1 December 2017

Thirty-fourth session

Amendments to Annex 7, examples 1 - 7

Transmitted by the United Nations Institute for Training and Research
(UNITAR)

Example 2: Combination packaging for a chemical classified in flammable liquids Category 1-specific2 and in Specific target organ toxicant and toxicity - Single exposure Category 2 flammable liquid 2

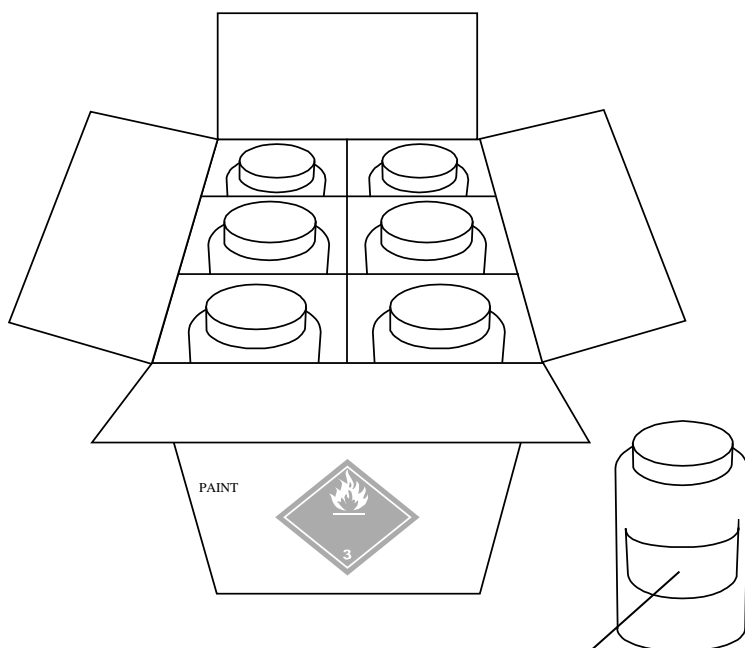
- (d) In examples 2 and 5 the type of STOT is given, i.e. Single exposure in example 2 and Repeated exposure in example 5, to make it clear.
- (e) In reviewing the seventh revised edition, UNITAR noticed that example 4 contains an exclamation mark, but no pertaining hazard given. This is acknowledged as a mistake and thus is to be removed as a corrigendum, as opposed to an amendment. Ultimately, the pictogram exclamation mark should be removed. This would complement document UN/SCEGHS/34/INF.11 on Corrections to the seventh revised edition of the GHS.

Hazard statements: **Highly flammable liquid and vapour.**
May cause damage to organs. (see 1.4.10.5.2 (b))

Precautionary statements: **Keep container tightly closed. Do not breathe mist, vapours, spray.** (see 1.4.10.5.2 (c)) and for further applicable P statements Annex 3 Section 3)

Example 7: Additional guidance when transport and other GHS information appear on single packagings

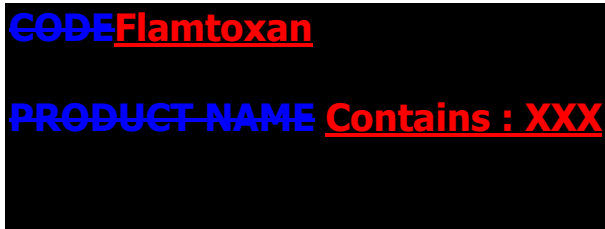
- (f) At the end of the Notes to examples 4 and 5 an addition is proposed: “(see Example 7)”
- (g) Example 7:
 - (i) In the additions to the proposed introduction under (e) the following text is added: “Whereas some regulatory authorities require a size of the pictogram ‘sufficiently wide to be clearly visible’, others prescribe a minimum size or certain relation of the pictogram size to the size of the whole label.

- (ii) At the end of the introduction the following section: “This example does not intend to cover all specific requirements which have been included in national legislation with the implementation of the GHS nor all possible additional information. It reflects rather the required basic GHS information as described in paragraph 1.4.10.5.2.

- “Code” and “Product name” are substituted by the name “Flamtoxin”
- With respect to the suggestion that the chemical identities of ingredients contributing to acute toxicity should be included in the label, the item “**Contains XXX**” is added. (see paragraph 1.4.10.5.2 (d) (ii))
- Emergency phone number was removed, since in the GHS it is only a requirement for SDSs

- The statement “Read label before use” was moved up in order to fulfil its intended purpose
- P102 - Keep out of ~~the~~ reach of children” was removed, since the product is not for consumer use (a 200 l drum; s. Annex 3, Table A3.2.1)

- The size of the GHS pictograms has been slightly increased in order to emphasize its eye-catching function, thus, taking the original proposal of UNITAR and concerns expressed during the discussion of proposal 5(e) in INF 9 for increasing the GHS pictogram size.

- The arrangement of the label element was structured to reflect the requirements in 1.4.10.5.4.1 in the order: Pictograms, Hazard statements and precautionary statements.

- P260 was adapted to applicable conditions, by removing the slash terms with dust/fume/gas to read as “Do not breathe mist, vapour, spray”
- P280 was adapted to “Wear protective gloves, protective clothing, and eye protection.”

- P370 + P378: The dots were substituted to read now as “In case of fire: Use dry powder to extinguish”
- The word FIRST AID was removed, since it is not a type of P statement according to Annex 3, A3.2.2.1 and not necessary.

- P312 – Specified by deleting POISON CENTER in order to read “Call a doctor if you feel unwell”

Removal of (Universal Product Code (UPC))

- (e) The pictograms may be distinguished by adjusting their size. Generally speaking, the size of the non-transport pictograms should be proportional to the size of the text of the other label elements. This would generally be smaller than the transport-related pictograms, but such size adjustments should not affect the clarity or comprehensibility of the non-transport pictograms. Whereas some regulatory authorities require a size of the pictogram “sufficiently wide to be clearly visible”, others prescribe a minimum size or certain relation of the pictogram size to the size of the whole label;

- (f) This example does not intend to cover all specific requirements which have been included in national legislations with the implementation of the GHS nor all possible additional information. It reflects the required basic GHS information as described in paragraph 1.4.10.5.2
